Interactive comment on “Atmosphere-only GCM simulations with prescribed land surface temperatures” by D. Ackerley and D. Dommenges

D. Ackerley and D. Dommenges

Fig. 1. The difference in (a) surface long-wave emission (upwards, W m^{-2}), (b) upwards latent heat flux and (c) upwards sensible heat flux between CON1 and FREE.

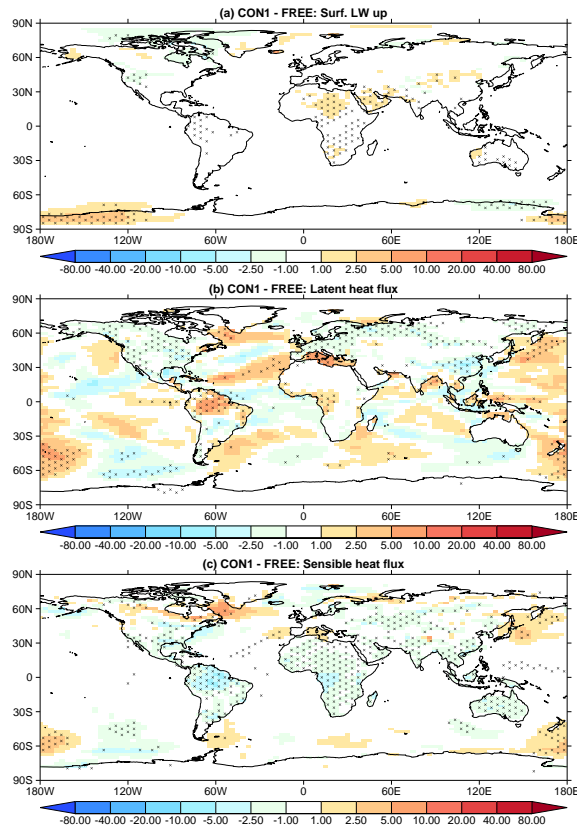
Sec 2.2.3: Are there any implications for the surface energy balance in prescribing the surface temperature, or is any implied imbalance absorbed in the radiation terms? Did you do any checks to confirm this?

Response: The responses of the surface fluxes are plotted in the attached FIG. 1 below. The differences in each of the fluxes are small (generally within $\pm 2.5 \text{ W m}^{-2}$) despite there being some statistical significance, which is not surprising given that over 50 years of simulation even small systematic differences are likely to be significant (although physically irrelevant in terms of the resultant climatological state e.g. global circulation). Given these small changes, the inclusion of these results in the main text will not change the conclusions or provide any more insight. Furthermore, as this figure will be published (and freely available) with the review responses, readers will be able
